Type Coffee Vending Machine	Model 9100 - 9200	N° T.I. 11 - 2019	
Serial Number 93110336	Subject NEW DRIP TRAY PLASTIC PROFILE	ISSUED FOR (X)	Action Information X

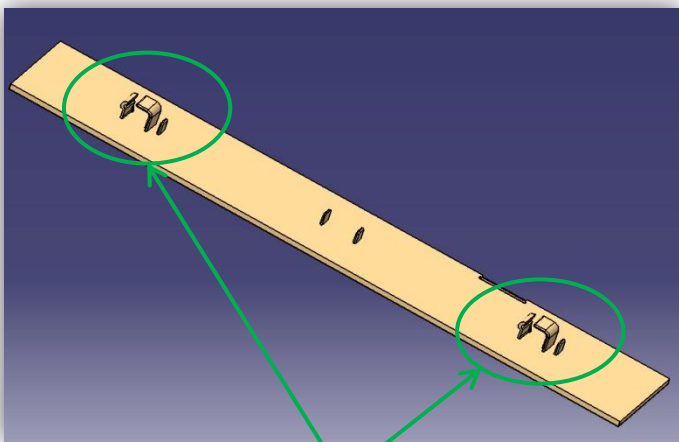
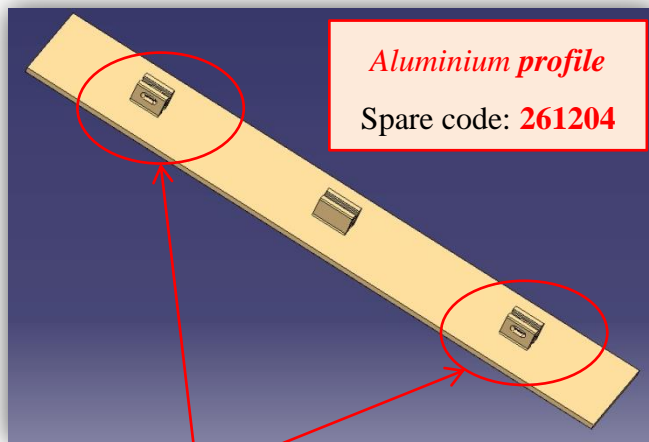
Be informed that with the aim to reduce costs

The *aluminium* drip tray profile has been replaced by a *plastic* profile

aluminium profile + *N.2 fastening clips*

Clips included in the new molded profile

New solution: plastic profile (black)

Spare code: **262043 sap 55120277**

For machines previous to above **S/N** it's possible to use **new plastic profile**, that replaces *aluminium profile* + *N.2 fastening clips*
